ERIE COUNTY WATER AUTHORITY  
AUTHORIZATION FORM  
For Approval/Execution of Documents  
(check which apply)

**Contract:** 19-02-01

**Project Description:** Large Service Contract

**Work Change Directive No. 1**

Figure 1

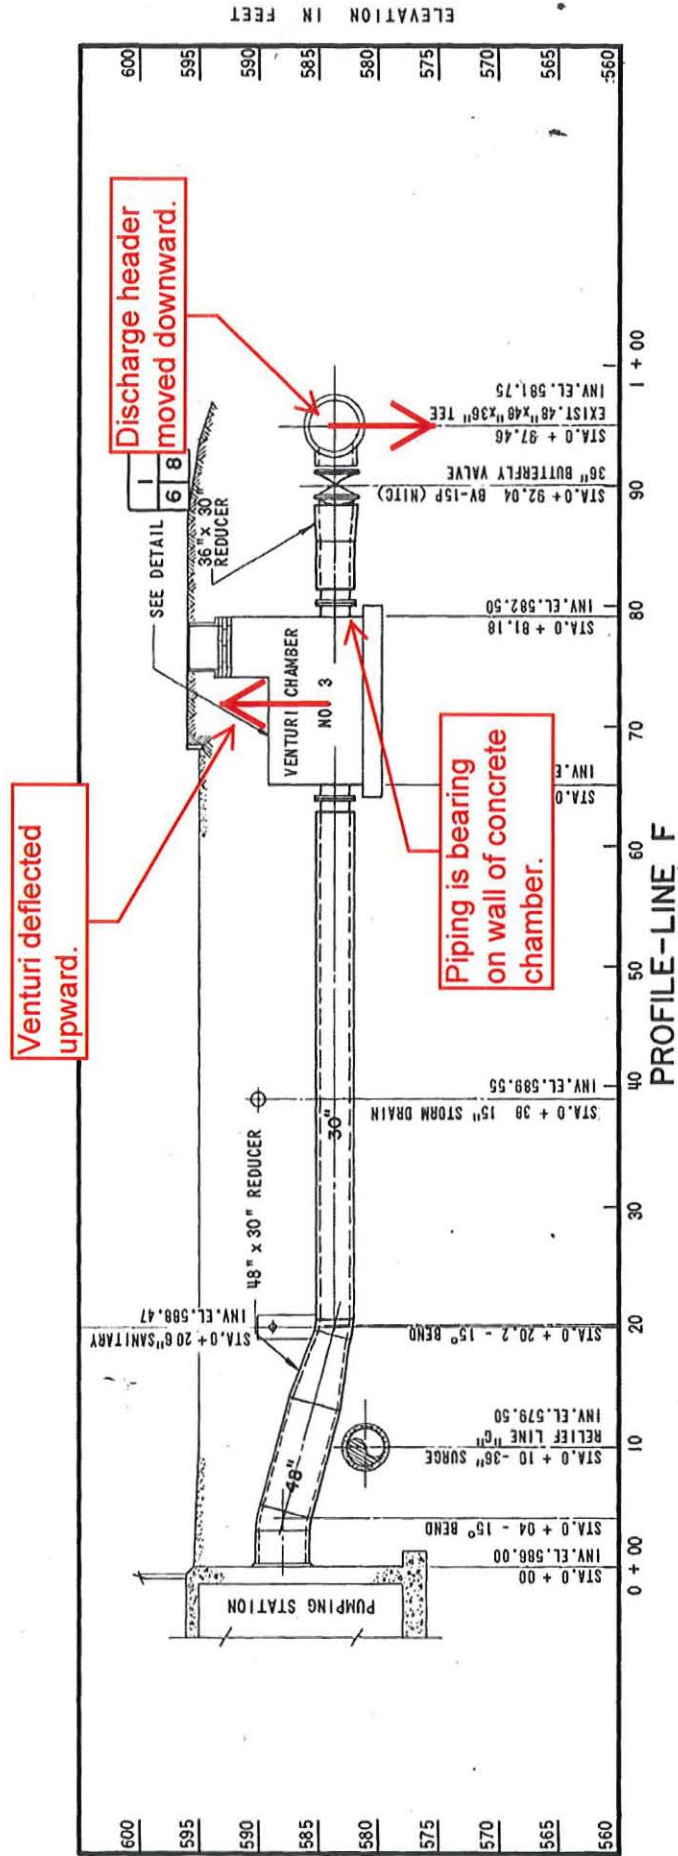
On December 16, 2019 a Pump Mechanic was investigating a high-water alarm at the northern venturi chamber at Ball Pump Station. While he was in the chamber, he noticed that the piping in the chamber is out of alignment. The venturi is currently lifted off its concrete support and the piping at the eastern end of the chamber is bearing on the chamber wall. For the venturi to be lifted off its concrete support, the discharge header outside of the chamber had to move downward. Figure 1 shows the piping layout in the vicinity of the venturi chamber. The current condition of the northern venturi is shown in Picture 1. The central venturi is also displaced, but to a lesser extent. The southern venturi did not show signs of displacement.

Insulation is pushed forward.
